Public Service  
Company of Colorado

October 29, 1985  
Fort St. Vrain  
Unit No. 1  
P-85384

SUBJECT: Fort St. Vrain Control  
Room Design Review  
Summary Report

Public Service Company  
Response to the  
Nuclear Regulatory Commission's  
"request for additional information"  
(Detailed Control Room Design Review Summary Report)

HED 0825  
Page 5 of 5

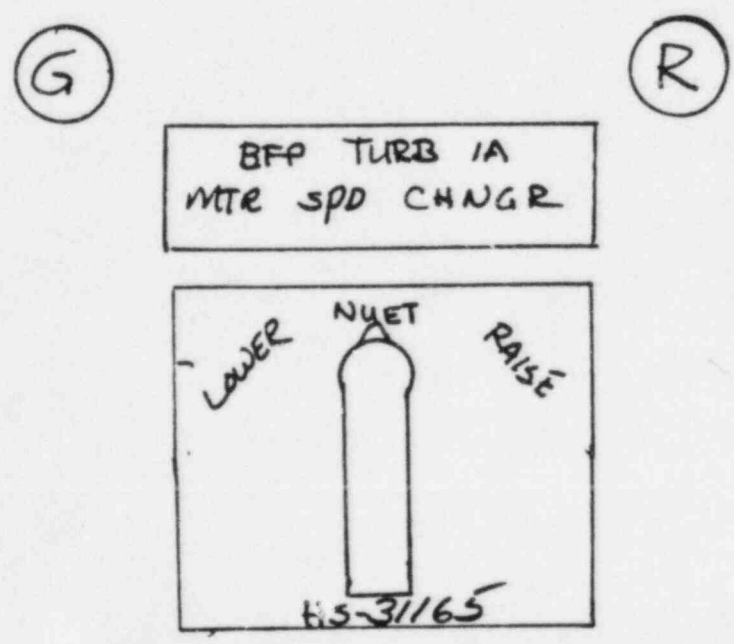
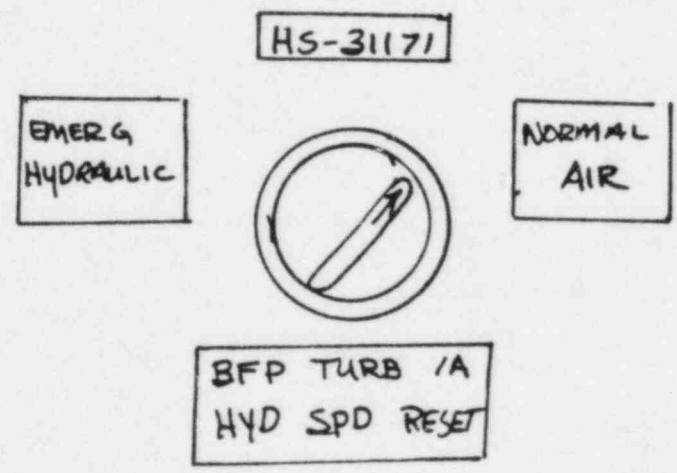
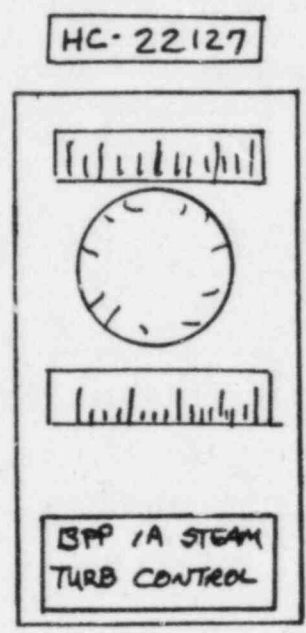
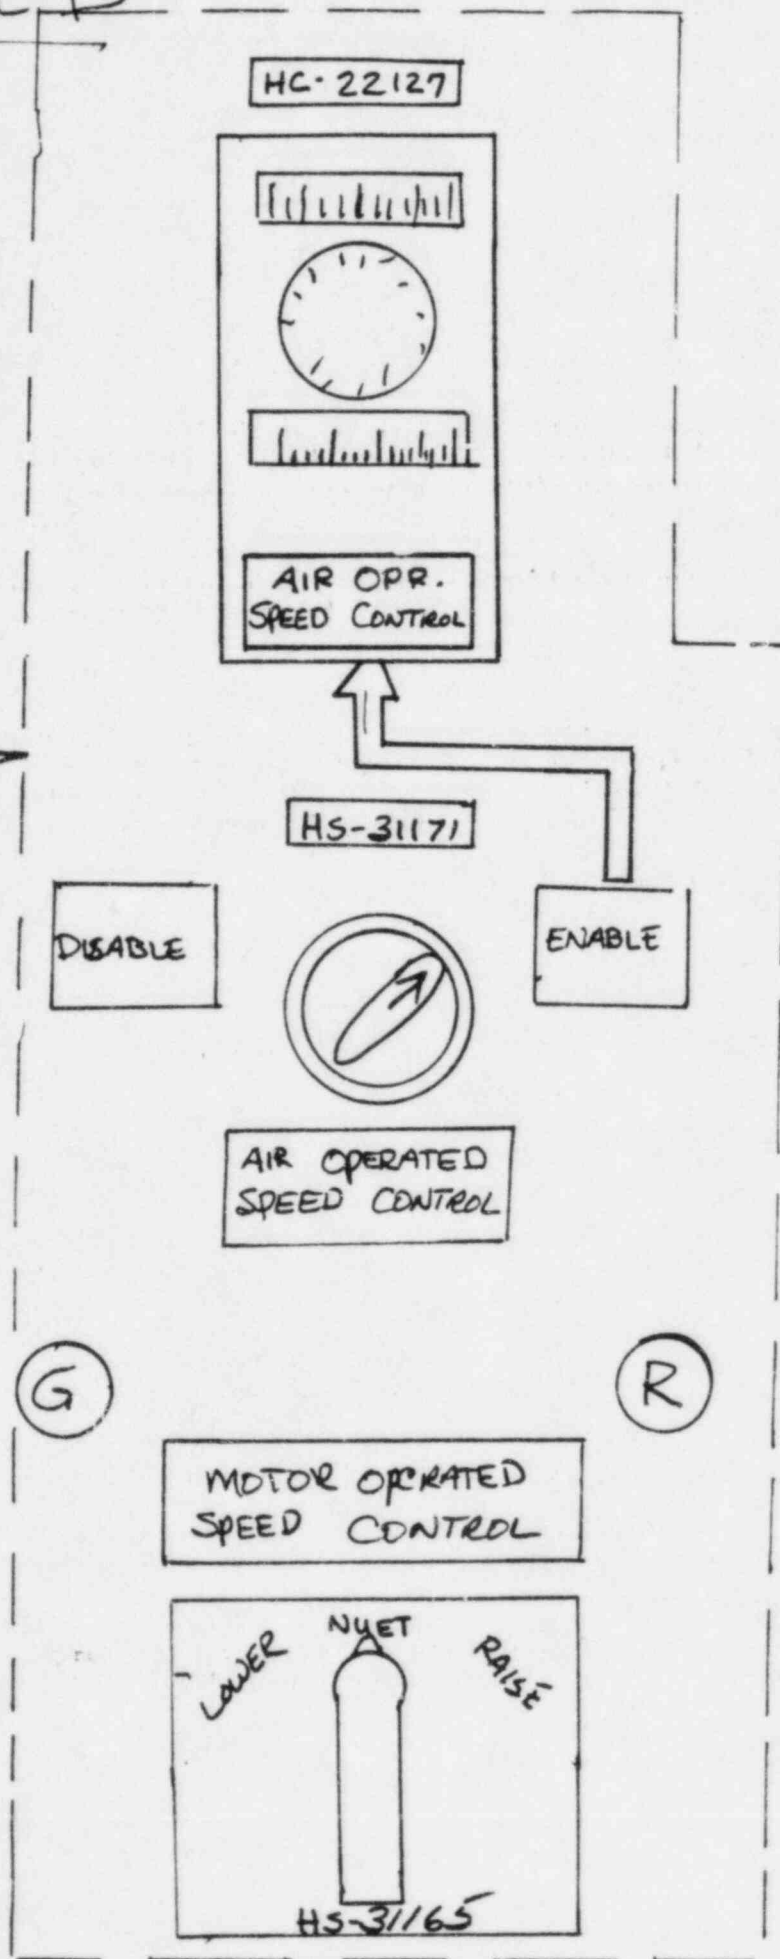
The existing functional labeling for HC-22127/8, HS-31171/2, & HS-31165/6 implies an option between "air" and "Hydraulic" speed control for the BFPs 1A & 1C, i.e. "Normal Air" and "Emergency Hydraulic".

The vendor information available and a close field inspection of a disassembled unit in March 1984 does not support this existing concept.

The normal operation appears to be one of setting the setpoint or desired speed by HC-22127, an air (a 10-50 ma output controlling an air input to the air portion of the loading cylinder. In order to enable the action of this air control, the hydraulic pressure must be vented, <sup>or relieved</sup> from the hydraulic section of the loading cylinder. This is accomplished by HS-31171(2) supplying an electric signal to a solenoid. The existing markings on HS-31171 imply ~~and~~ a reset action and also emerg hydraulic. Again this concept is incorrect. The hydraulic pressure is supplied by the BFP and is constant at the speed control mechanism. The hydraulic positioning force is negated on the loading cylinder only to enable the effect of the Air Control and is

not an optional control means selectable in the event of air failure.

The attached sheets 3 and 4 show existing and proposed functional labeling for these controls

# ORIGINAL LAYOUT

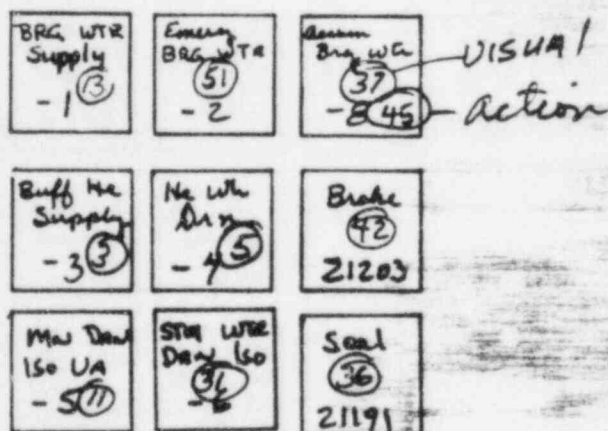
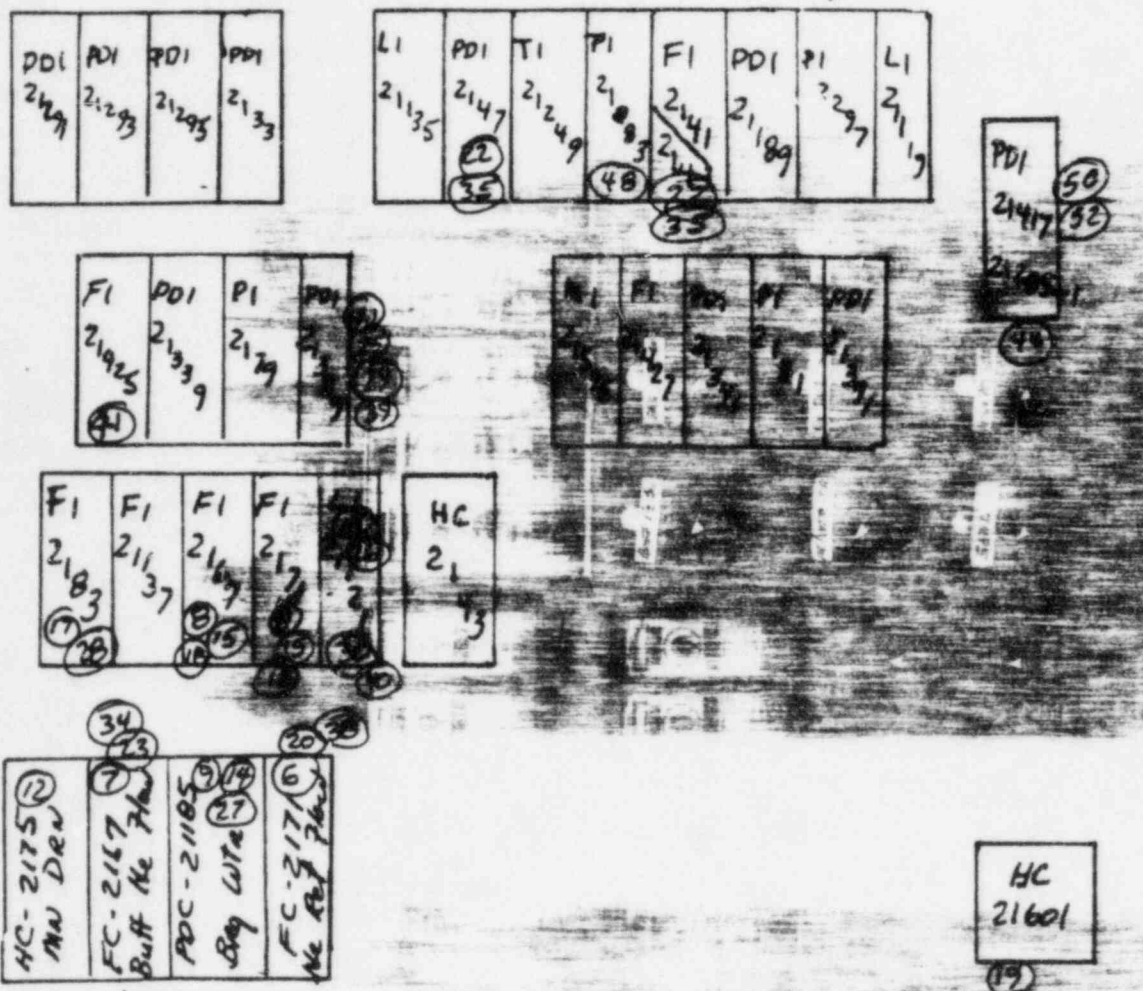
Summary - A re-arranged board placed those instruments required for a cinc start up in order of use and priority of parameter. This arrangement results in Big wh, seal system and Isolation function being located vertically with the controls and indications. Operator action verified that several instruments are not functionally

or geographically located for the most effective use during a fire start up.

Several HED's were generated citing:
